DETAILED ACTION

Continued Examination Under 37 CFR 1.114

Fig. 23: Moriau et al. (US 6,490,836)

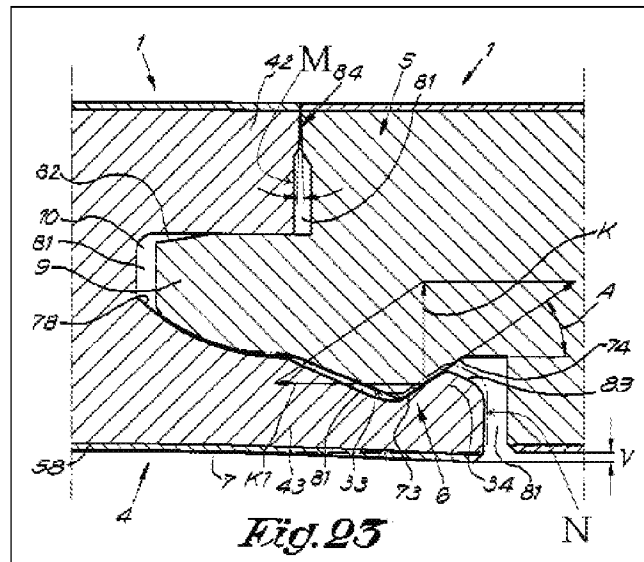
Moriau et al. further discloses the upper surface of a tenon (9) of the another floorboard overlaps the upper surface of the slot mortise (10) a distance before the self-locking surface is formed as the floorboard piece (1) is attached horizontally relative to the another floorboard (fig. 25). Examiner submits the lower surface of the slot mortise of Moriau et al. would not be subject to deflection when the tenon approaches the slot mortise, however, the lower surface of the slot mortise would experience bending/deflection when the tenon is forced into the slot mortise.

Moriau et al. fails to disclose the distance is no less than 1-2 mm.

However, Moriau et al. does disclose the front extremity of the tenon (9) is shaped to extend into slot mortise so as to prevent the front extremity from pressing against the front side of the short end (M) of the slot mortise (col. 12, lines 5-15).

It would have obvious to one of ordinary skill in the art at the time of invention to optimize the distance of the tenon of the another floorboard to extend no less than 1-2mm without deflection of the lower surface of the slot mortise of the floorboard piece and before the self-locking surface is formed between the floorboard piece and the another floorboard in order to provide a flooring structure with a tenon end or front extremity that does press against the short end of the slot mortise of the floorboard for preventing damage of the floorboards during installation.

Examiner submits the floorboard piece of Moriau et al. performs in similar manner to applicant's claimed flooring, which includes the upper surface of the mortise overlapping the tenon before the self-locking is formed (fig. 23 and col. 12, lines 5-15). *In Gardner v. TEC Systems, Inc.*, 725 F.2d 1338, 220 USPQ 777 (Fed. Cir. 1984), cert. denied, 469 U.S. 830, 225 USPQ 232 (1984), the Federal Circuit held that, where the only difference between the prior art and the claims was a recitation of relative dimensions of the claimed device and a device having the claimed relative dimensions would not perform differently than the prior art device, the claimed device was not patentably distinct from the prior art device.
